Multiroom Compatibility Firmware Update Release Notes

Mu-so & Mu-so Qb (v. 1.6)

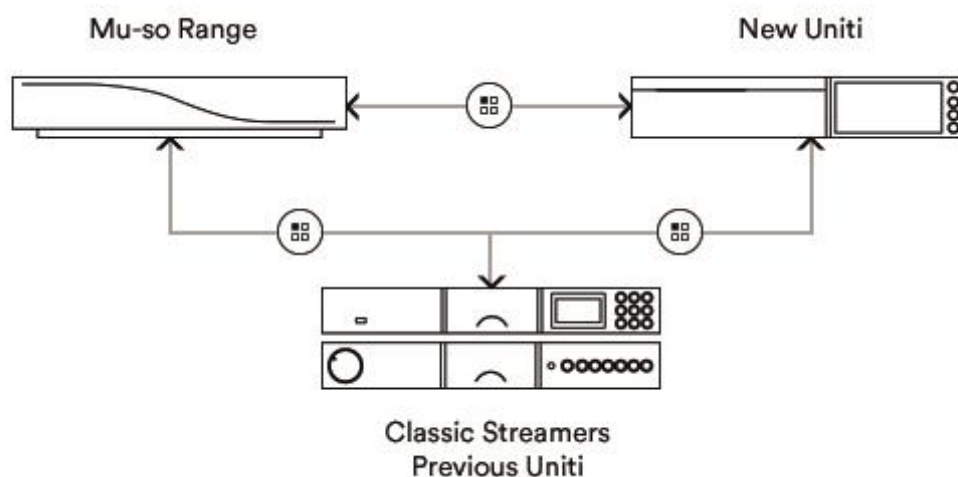
- Introduces numerous improvements to the multiroom picker interface to support the products and improve usability
- Improves the robustness of joining a multiroom group
- Improves the experience of the Mu-so and Mu-so Qb firmware update process
- Introduces the use of album artwork in situations where there is no artist artwork available
- Fixes an issue where CD input was incorrectly available to be disabled
- Fixes an issue where NAS shares were not selectable when configuring a backup
- Fixes an issue where shuffle and repeat may be displayed on inputs that don't support them
- Fixes an issue where max volume and balance may be missing from input settings
- Fixes an issue where the date may be incorrectly displayed for a firmware update

Prior to Update

With Update
